**Government of Telangana
Forest Department**

Rc.No.135/2018/D1, dtd.21.05.2022.

**Sub:** TS - Forest Department F (C) 1980- Diversion of 2.121 Ha of Forest land for formation of approach road for construction of HLB across Manjeera River from Dharmareddy to Muddapur (Via) Venkampally road PR Road in Kamareddy District in favour of Executive Engineer, R&B Division Kamareddy- additional information sought for by IRO, Hyderabad - Report submitted- Reg.

Typical cross of exisiting road section from km 0/450 to 1/100 (for a length of 750m)

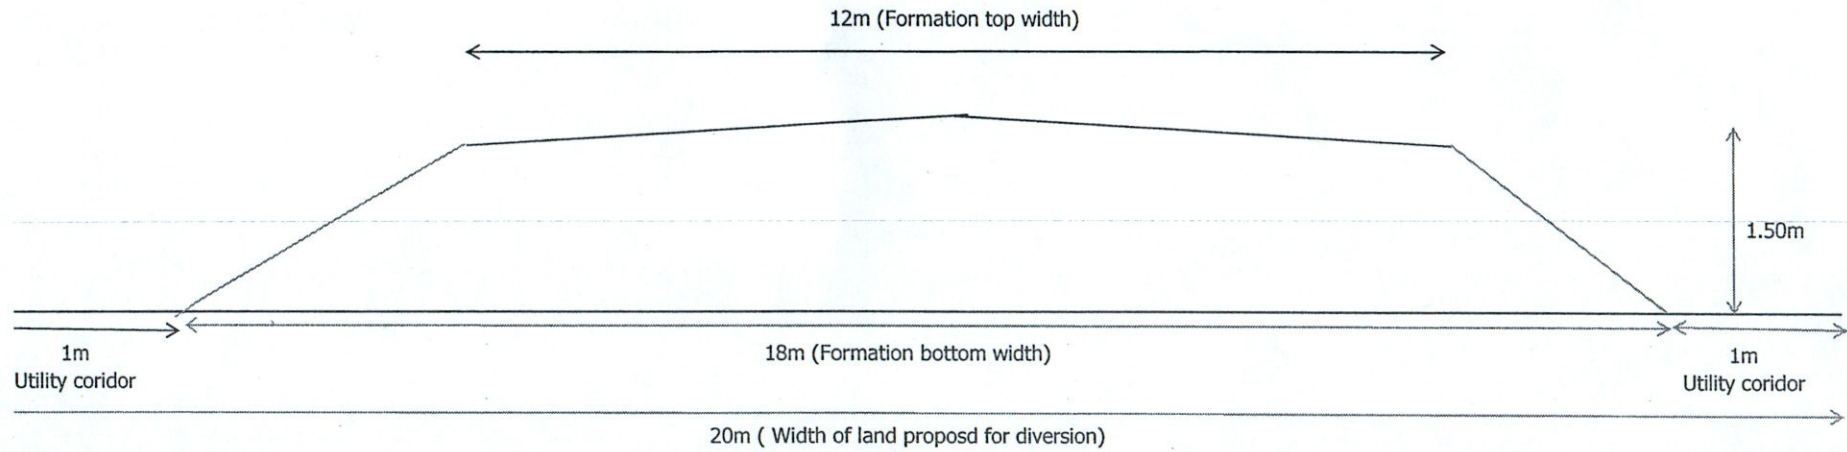
iii	Cross Section of the road with clearly indicating component wise details like actual carriage way (BT- portion) drainage shoulders etc may be submitted.	The EE R&B Division Kamareddy has reported that the existing road carriage way width is 3.66m with BT, and 1 m shoulders on either side of the road and there are no drains in this portion. (Typical cross section is enclosed).
iv	There is a deviation taken from the existing road with in forest area which could be avoided if the existing road is used. Hence this portion may be realigned along with existing road.	The EE R&B Division Kamareddy has reported that the road in forest are from km 0/450 to 1/100 (750m length) is improvement of existing single lane road, the road from 1/100 to 1/550 (450m length) is new alignment of the road by providing bypass road to Tandoor village. The existing road after Tandoor village is passing over canal bund, the double lane construction activity is not possible over the canal bund. So, alternate alignment is provided from km 1/100 to 1/550. Further, it is inform that, the road from km 1/550 to 5/590 is also new alignment formed by acquiring the private lands, which serves as an approach to newly constructed bridge across Manjeera river, (Site map is enclosed).

- c) The existing road carriage way width is 3.66m with BT , and 1m shoulders on either side of the road and there are no drains in this portion. (typical cross section is enclosed).
- d) The road in forest are from km 0/450 to 1/100 (750m length) is improvement of existing single lane road, the road from 1/100 to 1/550 (450m length) is new alignment of the road by providing bypass road to Tandoor village. The existing road after Tandoor village is passing over canal bund, the double lane construction activity is not possible over the canal bund. So, alternate alignment is provided from km 1/100 to 1/550. Further, it is inform that, the road from km 1/550 to 5/590 is also new alignment formed by acquiring the private lands, which serves as a approach to newly constructed bridge across Manjeera river. (Site map is enclosed).
- e) Issue pertains to the Forest Department.

proposed road alignment

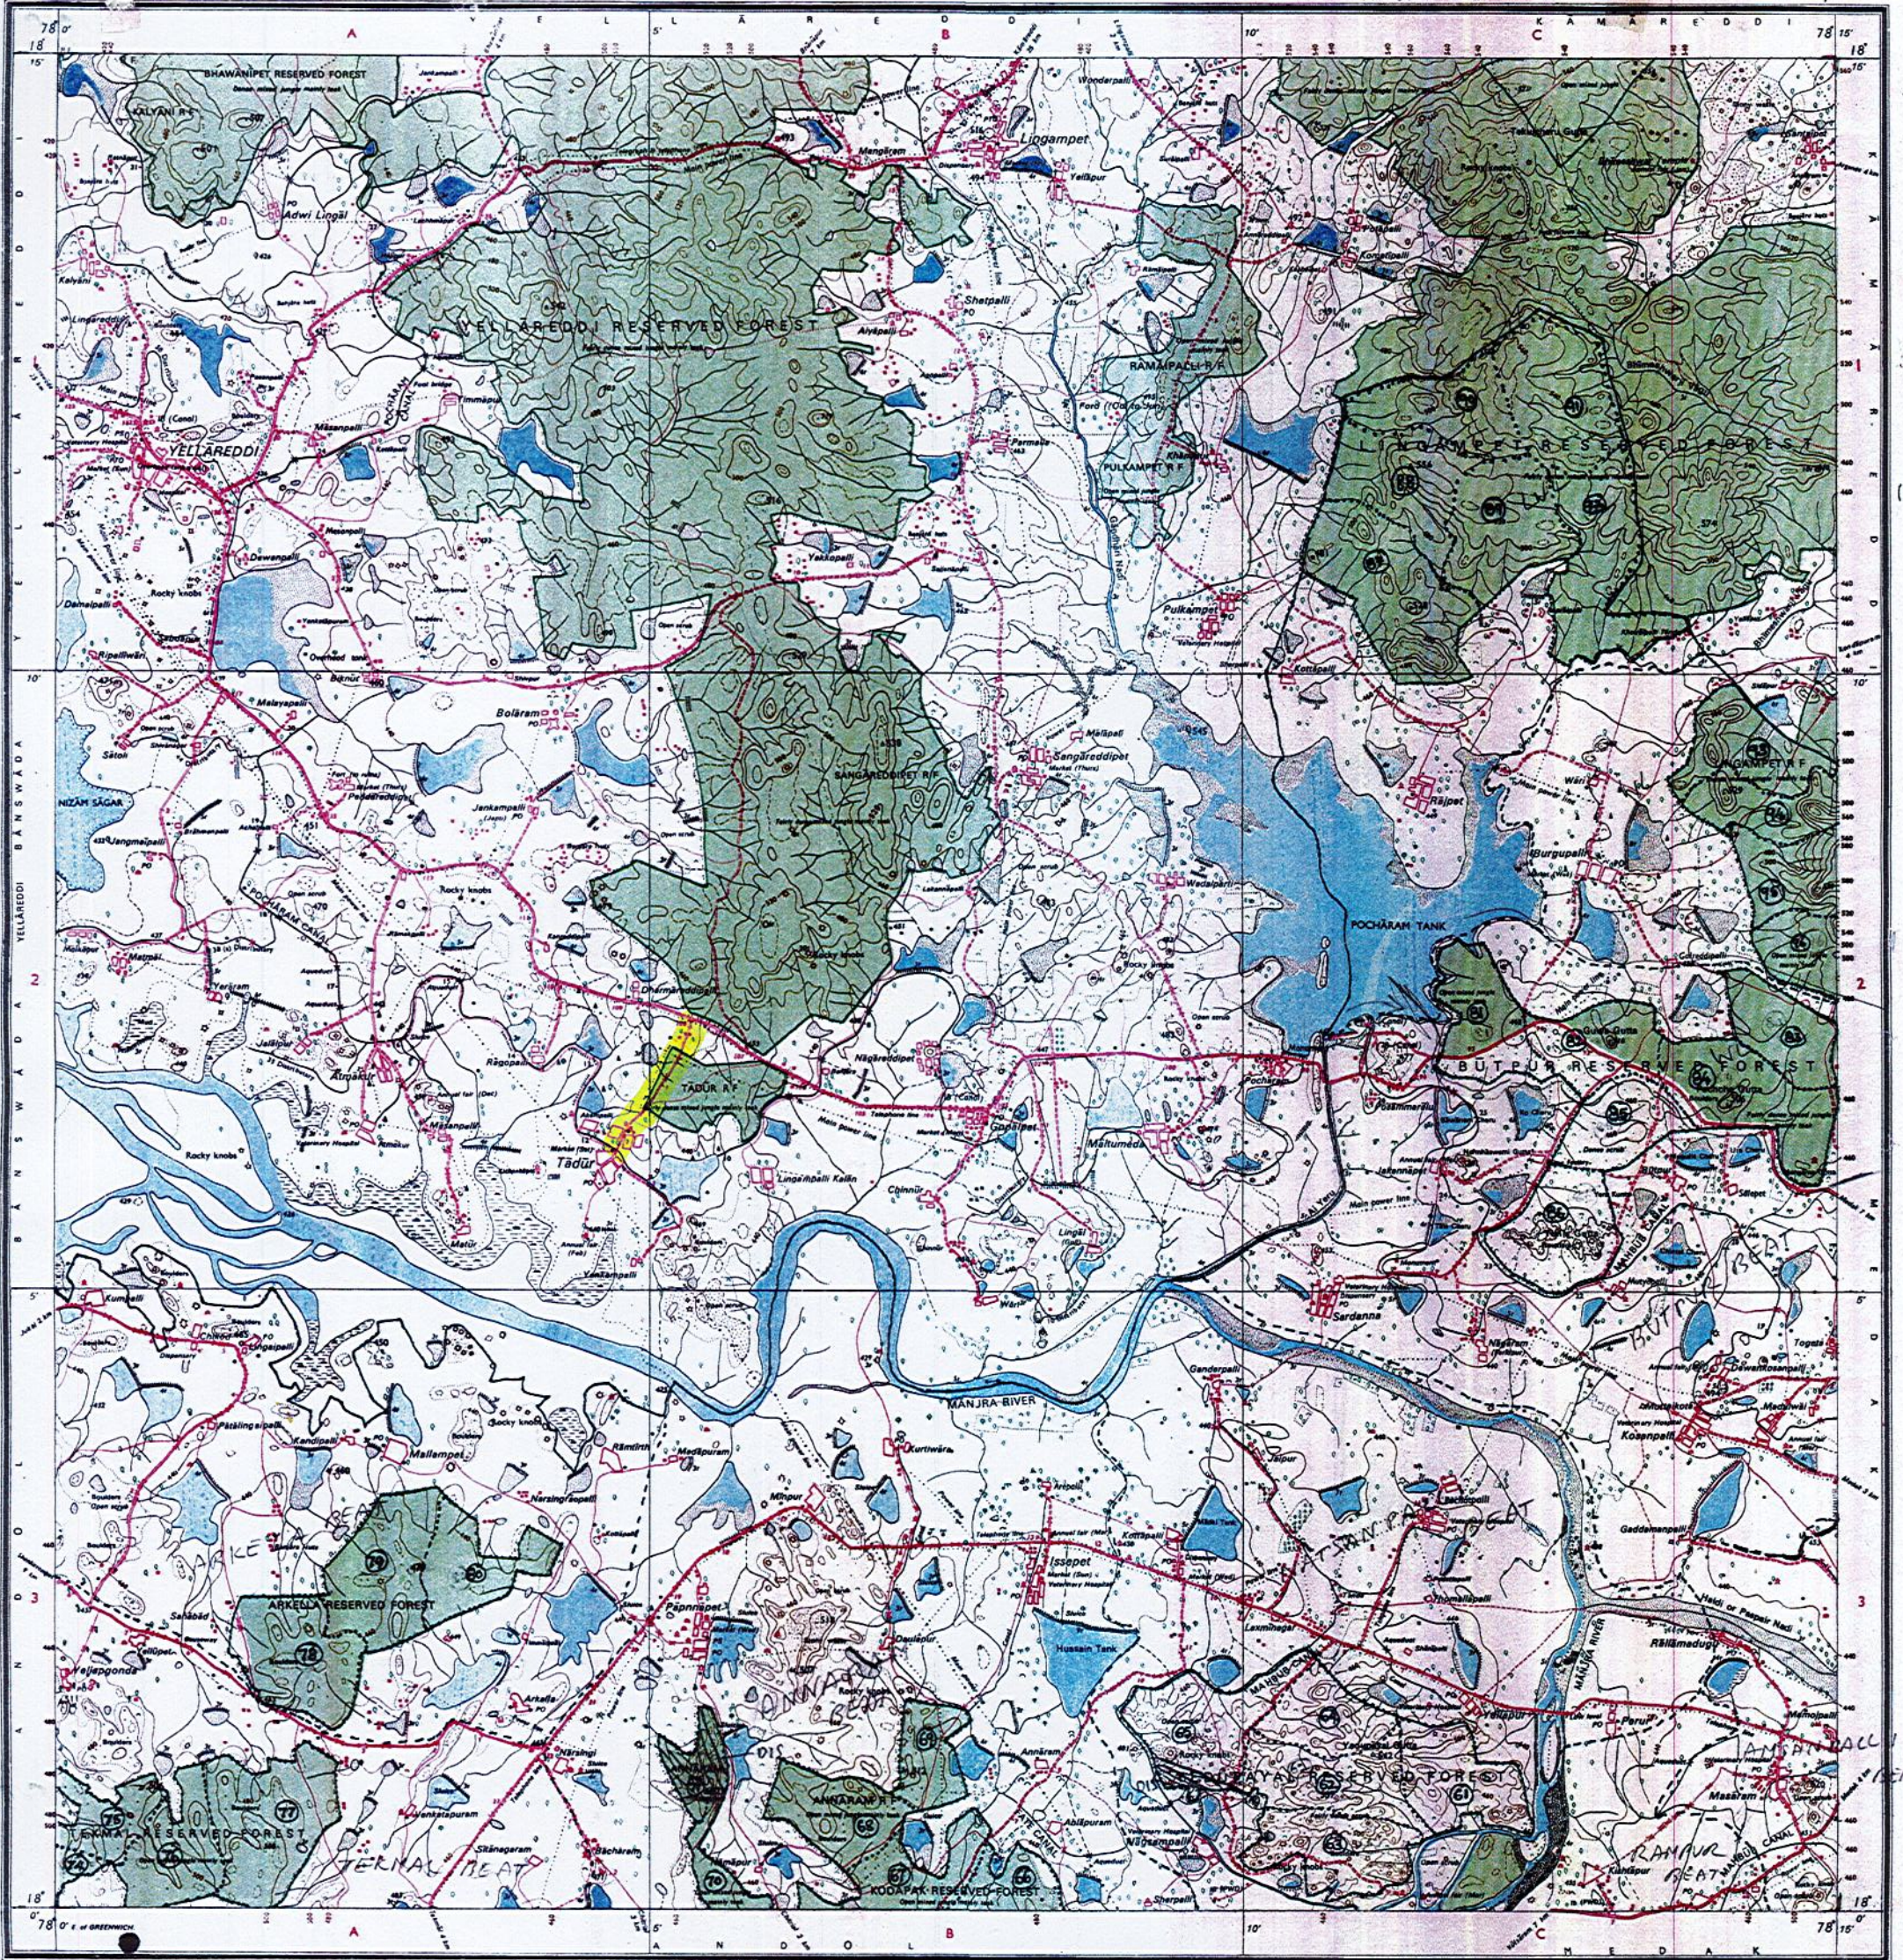
iv	There is a deviation taken from the existing road with in forest area which could be avoided if the existing road is used. Hence this portion may be realigned along with existing road.	The EE R&B Division Kamareddy has reported that the road in forest are from km 0/450 to 1/100 (750m length) is improvement of existing single lane road, the road from 1/100 to 1/550 (450m length) is new alignment of the road by providing bypass road to Tandoor village. The existing road after Tandoor village is passing over canal bund, the double lane construction activity is not possible over the canal bund. So, alternate alignment is provided from km 1/100 to 1/550. Further , it is inform that, the road from km 1/550 to 5/590 is also new alignment formed by acquiring the private lands, which serves as a approach to newly constructed bridge across Manjeera river, (Site map is enclosed)s
v	Part-II of the proposal in and signed by the DFO concerned is required to be submitted as per FC Rules, 2003 (amended upto 2007).	Enclosed (Part-II of the proposal along with the site inspection duly filled with signed)

Sl. No.	Additional documents /clarification	Reply
1	2	3
i	The User Agency reported that of existing road is constructed prior to 1980. However, the state Govt. had not provided details of RoW including length and width etc and also not submitted documents like RF notification mentioning the etc. Hence, detailed report along with the supporting documents may be provided.	The EE R&B Division Kamareddy vide reference 3 rd cited has reported that the road was formed prior to the year 1980 with single lane BT road. However, the diversion proposal was submitted for entire width of the road. The proposed bridge is new river crossing and there is no existing nearby structure/Bridge on the river. This road forms approaches to the newly construction Bridge. By constructing the bridge and developing the approaches, there will be inter district connectivity between Kamareddy and Medak Districts. This road connects two National Highways i.e. Sangareddy-Nanded-Akola road (NH161) and Hyderabad-Medak-Bodhan(765D) road (Survey of India topo sheet is enclosed).
